**RE: File: SD-2021-001/ENG-2021-019/SEPA-2021-010
Harbor Grove Subdivision**

Please accept the following comments regarding the Determination of Non-Significance issued on August 30, 2023 for the Harbor Grove preliminary seven-lot subdivision.

Figure 1 – Impact of Stormwater Pump System Failure on Rugosa Ridge Properties

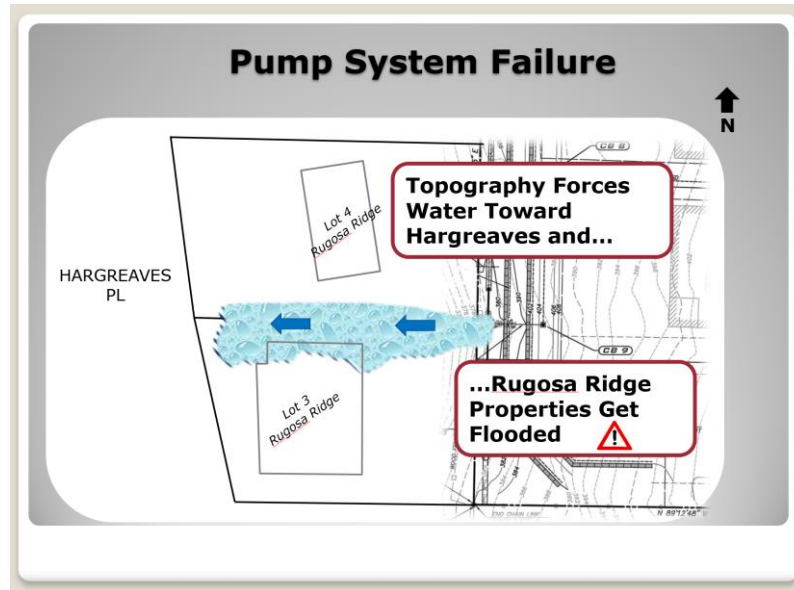
a. Drainage swale and pump system. The project includes a drainage swale and pressurized pump system (i.e., force main) to collect stormwater runoff along the project's western boundary. The applicant proposes this system as part of a private stormwater system to be owned and maintained by the future Homeowners Association (HOA). It will not be owned or maintained by the City of Mukilteo. This is a complex and specialized system that will require skilled personnel to inspect, maintain and repair it. And it will be expensive. This work is beyond the capabilities of a small, 7-lot HOA and will require a specialized consultant to be contracted with the HOA, per the Applicant response letter dated 4-21-23. Further, it is not clear the City will have legal authority or the resources to compel the HOA to take the following actions, which will be necessary steps to ensure the system functions properly over time:

The potential impact of a drainage system failure must be evaluated and avoided or mitigated.

Figure 2 – Illustration Showing Difficulty of Access to Improvements on Lot 6

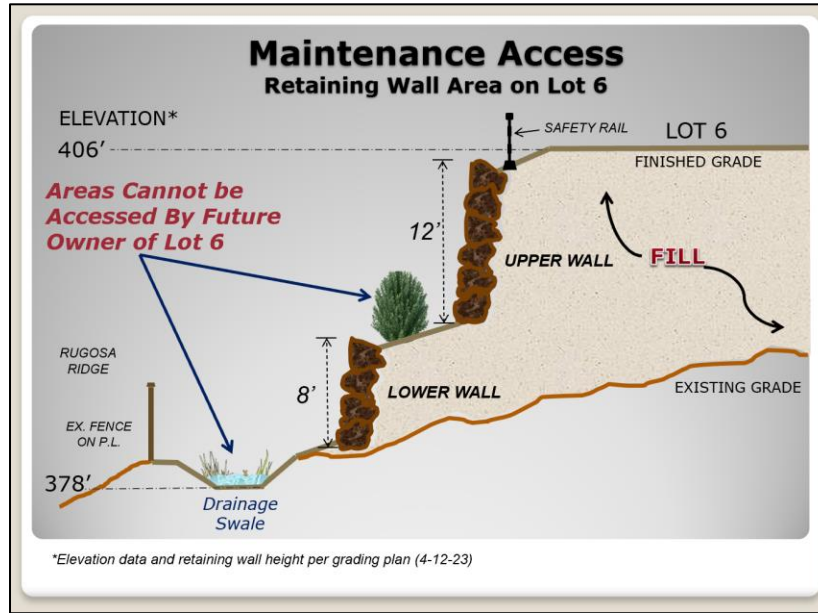
- b. Landscaping along western retaining walls. Regular landscape maintenance includes irrigation, debris removal, weeding, pruning and mulching. The proposed landscaping improvements located at the base of and in between the retaining walls cannot be maintained due to the height, length and location of the walls. No irrigation of the landscape areas is proposed (*see Landscape plans on file*). The continuous wall design will prevent the transport of materials and equipment to and from the landscape areas. The inaccessibility of this area will lead to accumulation of leaves, weeds and debris. Importantly, the landscaping will provide no tangible benefit to the future property owners of Harbor Grove since it will not be visible. It will only exist for the presumed 'benefit' of the residents of Rugosa

Ridge. This will greatly reduce the incentive for future residents of Harbor Grove to perform maintenance work. When the landscaping dies due to lack of maintenance and irrigation, it will become a visual nuisance that gets worse over time as dead plants, weeds and debris accumulate.

The use of covenants and restrictions to require maintenance of the landscaping in this area will be ineffective when the future homeowners cannot see it or gain access to it. The City would be approving a project design that creates a non-maintainable condition and becomes a source of conflict between existing owners in Rugosa Ridge and future owners in Harbor Grove. It is setting the stage for future enforcement action by the City and ultimate failure.

Figure 3 – Diagram showing location of retaining walls within rear setback

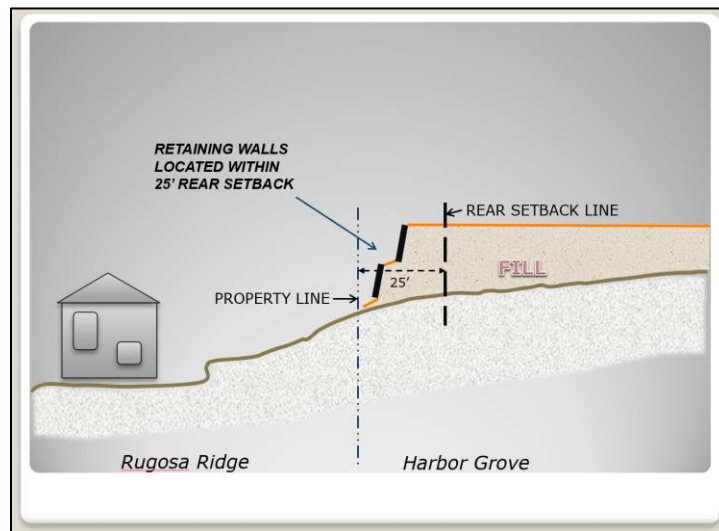
The proposed retaining walls along the western boundary of the project are located within the 25-foot rear setback required by the zoning code (*Figure 3*). The lower wall would be within 12 feet of the property line, while the upper wall would be within about 20 feet. The total length of the lower wall would be 170 feet, while the upper wall would be 250 feet. The combined height of the walls would be up to 20 feet on Lots 6 and 7, in the southwest corner of the project site. Both walls would exceed six feet in height in places. The purpose of the walls is to enable the grade of the site to be raised and leveled such that it is significantly higher than the surrounding properties.

The City maintains that retaining walls are not freestanding walls and therefore are not required to meet setback regulations for walls, fences or other structures (*Galuska email 2/3/23*). Under this reasoning, there is no limit to the height of retaining walls within setback areas. In other words, the Planning Department maintains the walls

The proposed walls along the western and southern property lines are both retaining walls *and* freestanding walls under city code and must meet the height and setback provisions under 17.20.080.A.2.a. They are also required to meet the setback standard because they are structures. A variance application is required for wall height exceeding eight feet within the 25-foot rear setback. The variance application must be processed as part of the Harbor Grove subdivision application and provided to the Hearing Examiner for review and approval. Without a variance request, the application is incomplete and the SEPA threshold determination has been issued in error.

Figure 4 – Building Height examples – with and without project

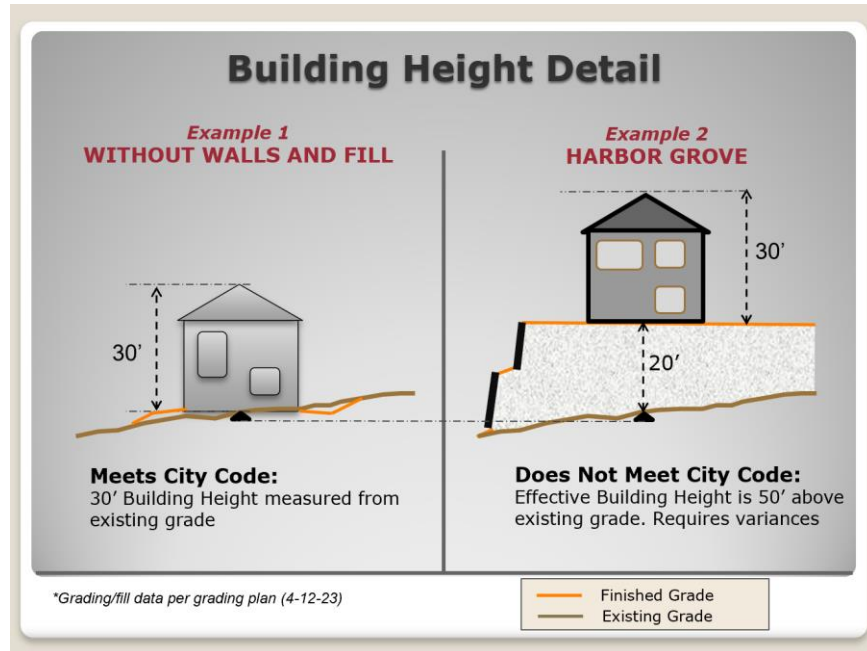
Under [MMC Section 17.20.020 - Structure bulk matrix](#) – maximum building height in the RD 12.5 zone is 30 feet from *existing grade*, as stated in the City’s requirements for building height calculation. The finished grade on Lots 4 through 7 is proposed to be elevated by up to 20 feet above existing grade. Calculation of building height based on the finished grade would result in future residences being allowed to have 30 feet of building height on top of 20 feet of fill for an overall height of up to 50 feet above the existing ground level (*Figure 4*). Applying the building height standard in this manner would be absurd and would create significant impacts on adjacent properties. It would amount to a building height bonus. Buildings located at or near the 25’ rear setback line would tower over neighboring houses and yards, resulting in light and shadow impacts and loss of privacy, use and enjoyment. These impacts have not been addressed or mitigated.

The definition of building height provides an exception for plats and short plats based on an approved grading plan; however, this is a discretionary review process that must consider the impacts that would result from the large-scale regrading of a site. The purpose and intent of this exception is to allow for minor changes within the interior of the site necessary for reasonable grading for utilities, roads and building sites, while protecting adjacent properties and the natural setting from harmful impacts of artificial increases in site elevation and building height. It recognizes the need to create smooth, rather than abrupt transitions around the exterior margins of a subdivision. It is intended to consider the balancing of cut and fill, rather than a net import of fill material (10,000 cubic yards) as proposed in the project. The building height exception connected to approval of a grading plan must be considered jointly with MMC 15.16 addressing grading and excavation. The City has applied the two sets of code provisions (zoning and grading) in isolation from each other in a manner that fails to consider impacts under SEPA and zoning.

A variance is required to allow future building height on the site to exceed 30 feet from the existing ground elevation. The City has not provided justification for allowing future building height to be calculated from finished grade, nor has it documented the impacts of this interpretation.

Figure 5 – Slope Map Showing Approximate Breakdown of Slopes by Percentage

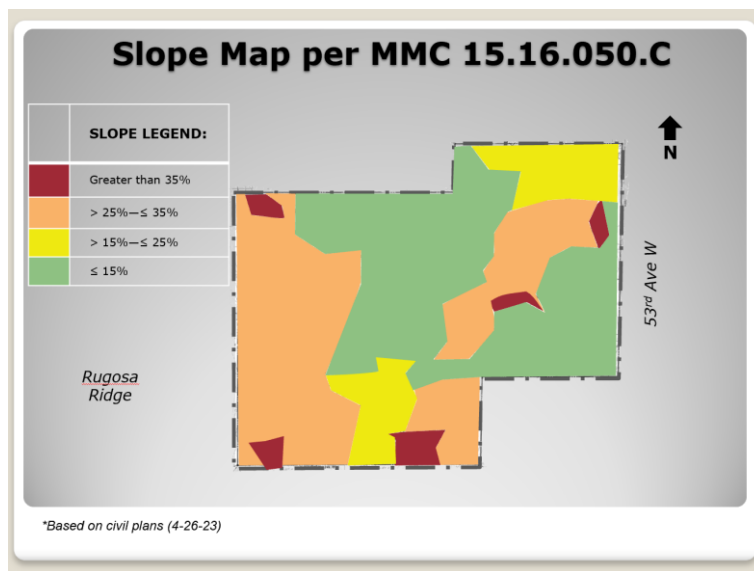
To meet the standards in Table 1 – Clearing Matrix, the application on file should have included a map showing a breakdown of on-site slopes according to steepness. Such a map can be prepared easily using Autocad or other common engineering software. See Figure 5 below, which shows the site to be anything but flat...

The application fails to comply with the requirements of MMC 15.16.050.C – Table 1 because it does not provide slope category and vegetation removal data. It uses the “average slope” of the property, which is incorrect because it does not acknowledge that a significant portion of the site is greater than 15% slope. The

Figure 5 – Map of Project Showing Location of Drainage System and Access Road

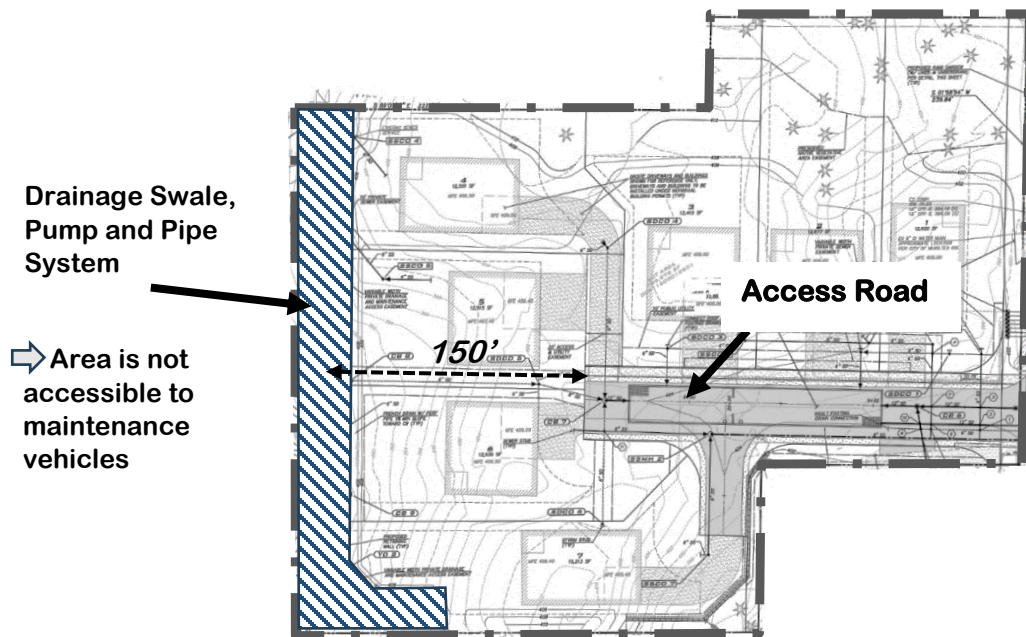
Analysis: The stormwater drainage swale, pump and pipe system will be located at the base of a large retaining wall and would be inaccessible from any road or driveway. The nearest road would be approximately 150' as the crow flies, and the actual travel distance on foot would be much further (see Figure 5 below). At this location, it would be physically impossible to provide vehicular access to this portion of the drainage system. As a result, all maintenance will need to be performed by hand and all materials and equipment will need to be hand-carried. This will greatly limit the type of work that can be performed and the frequency of maintenance.

The project design does not comply with stormwater facility access and maintenance standards because the stormwater pump system will be inaccessible to maintenance vehicles.
